Certificate of Appropriateness for 116 E Gilman

August 12, 2019

Proposed Work

South Elevation

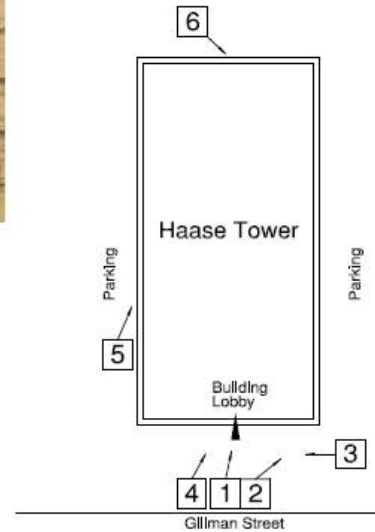
1. Approval of entranceway replacement with new windows either being clerestory or full length, new architectural tile installed over existing pebble-dash panels with color to be approved by staff, and replacement of door as proposed.
2. Approval of curtain wall replacement with new curtain wall to replicate original design, utilizing aluminum framing and low-e glass with low iron content.
3. Refer decision on signage for a future submission, or administrative approval by the Preservation Planner.
4. Approval of new parking lot surfacing as complies with other City requirements.

Demolition Plan

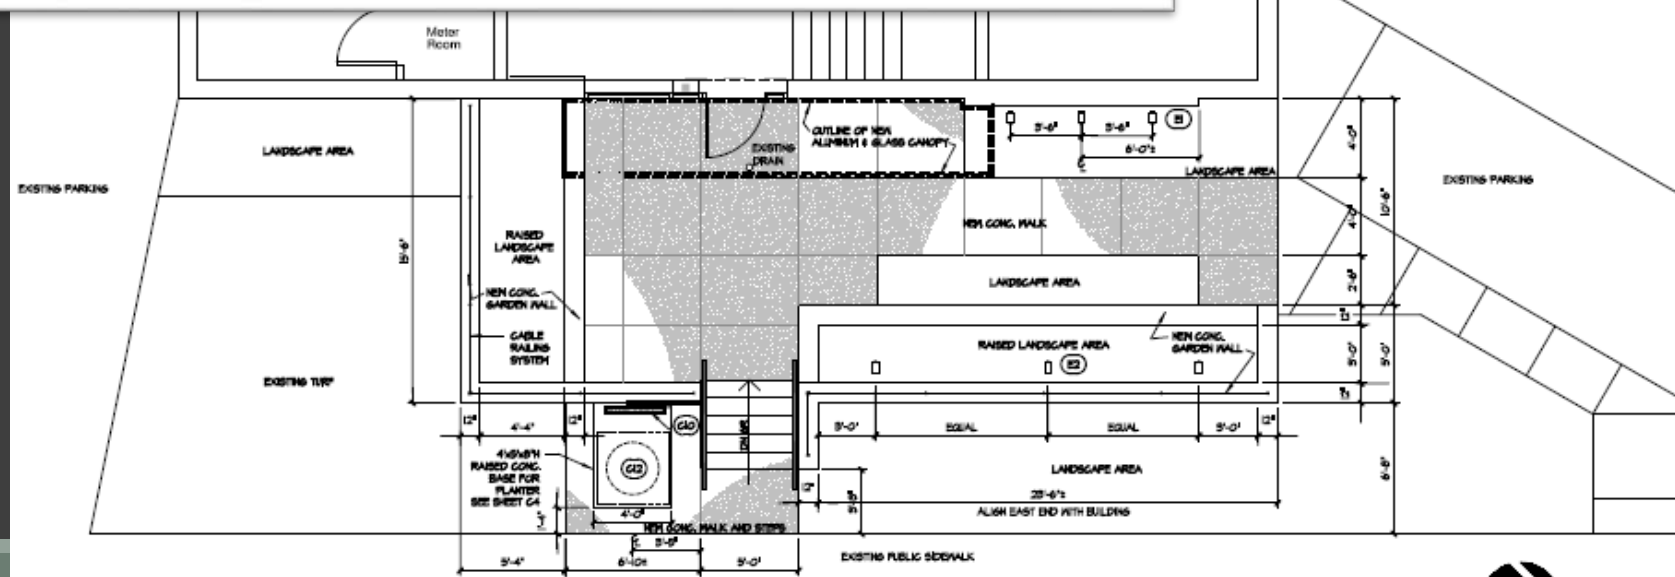
2
SCOPE OF WORK IN PHOTOS 1 - 2 - 3:
REPLACE GLASS ENTRY OF BUILDING LOBBY - ADD NEW WINDOW TO LEFT OF DOOR.
REMOVE EXISTING AWNING AND REBUILD ORIGINAL CANOPY TO ALIGN WITH NEW ENTRY GLASS.
REMOVE AND REPLACE EXISTING CONCRETE STEPS AND WALK.
REMOVE AND REPLACE EXISTING GARDEN WALLS AND LANDSCAPE.
